RE: SSD-11802230 SYDNEY OLYMPIC PARK NEW HIGH SCHOOL SSDA RESPONSE TO SUBMISSIONS ON TRAFFIC

Table 1 Response to submissions on traffic and Transport

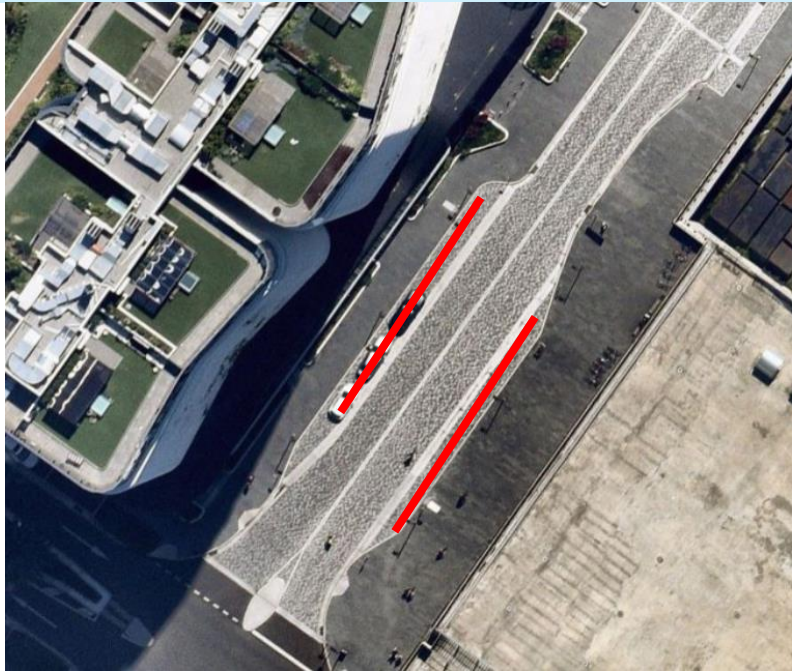
H 3	The architectural plans show 5 parking bays on Burroway Road proposed to be allocated for kiss and ride. The traffic report states that 2 additional	The full extent of kiss 'n drop demands will not occur immediately in line with the estimated 350 student in the first year of operation and will	Additional information

Our ref	Submission	Response	Type
	<p>parking bays in the new access road can be allocated to kiss and ride for students with special needs however this will be delivered by others. Based on this, a total of 7 parking bays for kiss and ride is provided for the school.</p> <p>However, as noted, the delivery of the new access road is unconfirmed at this stage. This will result in only 5 kiss and ride spaces provided for the new high school. However, the traffic report estimates that 190 students within the proposed school catchment will travel to school by car. The report further states that by providing limited kiss and ride spaces, it will encourage the use of walking and cycling.</p> <p>It is considered likely that some students will travel to school by car as they live further away from the school and have longer travel times on public transport. The limited kiss and ride facility may result in parents using the nearby kiss and ride facility on Hill Road, impacting on Wentworth Point Public School. It can also lead to illegal parking behaviours (e.g. double parking, parking across driveways, etc.) and parents may pick up/drop off their kids further away from the school, impacting on parking amenities in neighbouring streets. This can also lead to increased traffic congestion due to parents queuing and waiting to use the facility.</p> <p>Therefore, the kiss and ride facility proposed to be provided on Burroway Road is unlikely to be adequate for the school. It is recommended that additional parking bays be allocated to kiss and ride along the frontage of the school. This however, will be dependent on the delivery of the new access road.</p> <p>It is also recommended that a turning facility be provided at the end of Burroway Road so that drivers can safely U-turn after using the kiss and ride facility</p> <p>Approval from Council and TfNSW is required to be obtained prior to construction under the Parramatta Traffic Committee process.</p>	<p>increase over time. Hence 7 parking spaces are not fully required until years after opening.</p> <p>Queuing was estimated using the following assumptions:</p> <ul style="list-style-type: none"> – 25-minute effective pick-up period – 80% of students are picked up within this window – 1.7 students per car – 190 students arriving by car – M/M/c queuing model <p>The typical number of vehicles in the queue for the kiss 'n drop facility would be 5.7 vehicles - approximately 36m of the queue.</p> <p>The turning head at the end of Burroway Road allows for a turning radius of 17m. The minimum turning circle diameter for a B99 vehicle is 12.5. This means that the 99th percentile largest car can use the facility with a single turning movement.</p> <p>As part of the refined design, an accessible parking space has been added to the Burroway Road frontage to ensure special needs drop-off is possible during the scenario where Stage 1 is operating prior to delivery of the eastern road. The total spaces along Burroway Road are now 4 standard kiss 'n drop spaces and 1 accessible kiss n' drop space. This raises no issues for kiss 'n drop operations. At the full occupancy of Stage 1 (850 students), just under 90 students would be using kiss 'n drop based on the forecasted mode share (compared to 190 assumed at full occupancy), which is a reduction in demand by 54%. A reduction in the number of standard kiss 'n drop spaces along Burroway Road from 5 to 4 would be a reduction in capacity by only 20%. The reduction in demand is much greater than the reduction in capacity. Overall, therefore, the kiss 'n drop is expected to operate satisfactorily and with less queues if Stage 1 operates without the eastern access road</p>
